# Recall Bulletin

## PRODUCT SAFETY RECALL

**SUBJECT:** Loss of Battery Charge – Replace Generator Control Module

**MODELS:** 2012-2013 Buick LaCrosse, Regal  
2013 Chevrolet Malibu Eco  
Equipped with eAssist

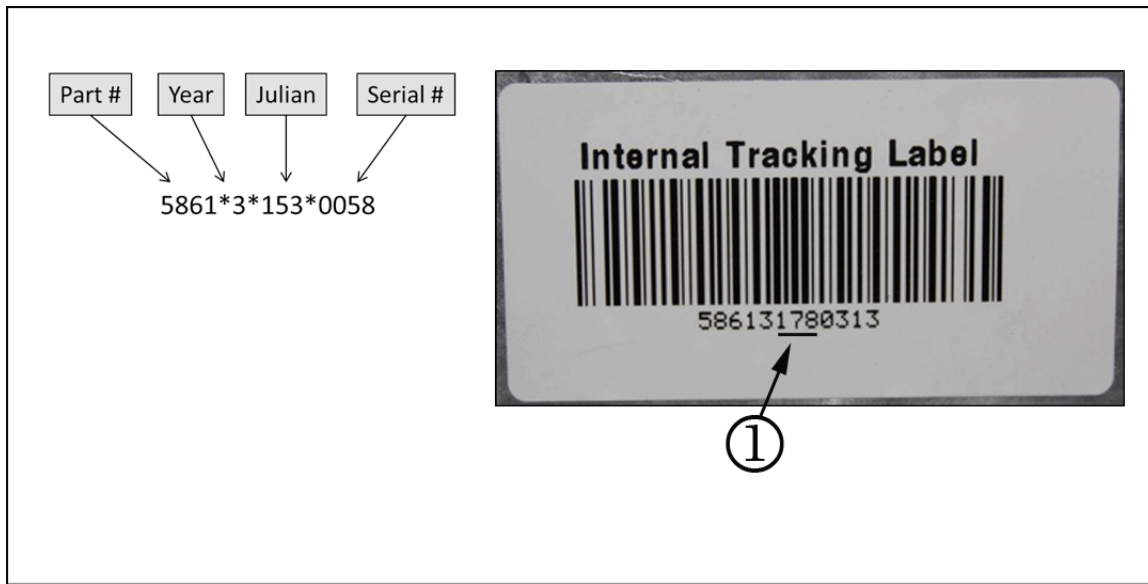
Generator Control Modules (GCM) with part number 24269448 or 24266403 require an inspection prior to installation in a vehicle. GCMs with part number 24267940 or 24267941 do NOT require inspection prior to installation in a vehicle.

Do NOT provide technicians with GCMs (p/n 24269448 or 24266403) that have a Julian date of 171 through 199. Determine the Julian date following the steps below. Return modules that fail the inspection according to Special Return Bulletin #G\_0000171850.

1. Locate the barcode label on the new GCM.

2. Determine the Julian date (1) as shown above.

- If the Julian date (1) is 171 through 199, do NOT install the module. Obtain another module and perform the inspection again.
- If the Julian date (1) is NOT 171 through 199, provide to the technician for installation in the vehicle.

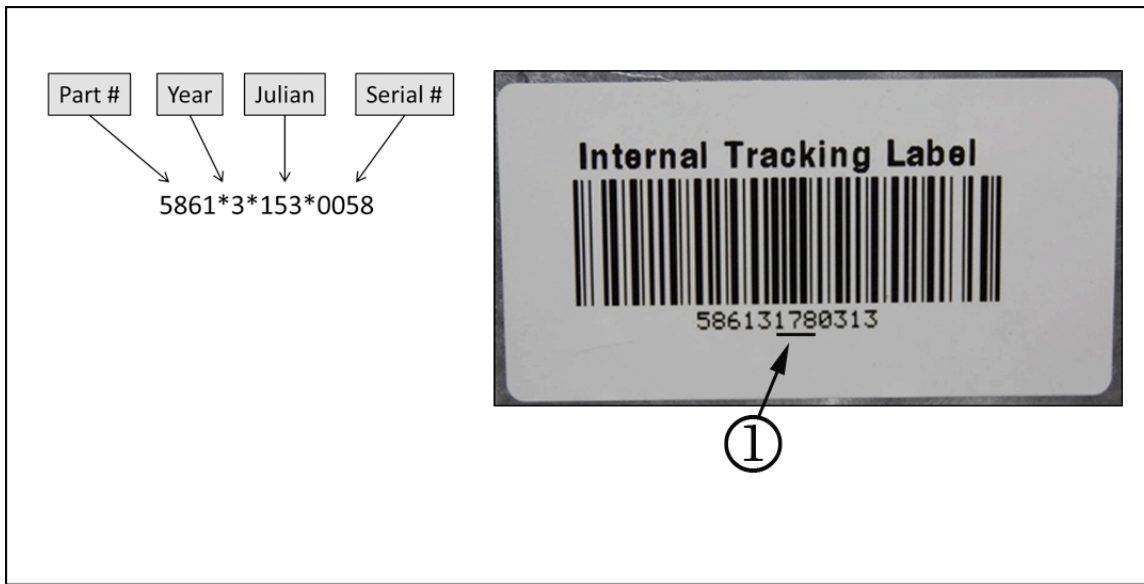
**Note:** Do NOT install GCMs with a Julian date of 171 through 199. Return those modules according to Special Return Bulletin #G\_0000171850.

3. Locate the barcode label on the new GCM.

4. Determine the Julian date (1) as shown above.
  - If the Julian date (1) is 171 through 199, do NOT install the module. Obtain another module and perform the inspection again.
  - If the Julian date (1) is NOT 171 through 199, proceed to the Installation Procedure below.
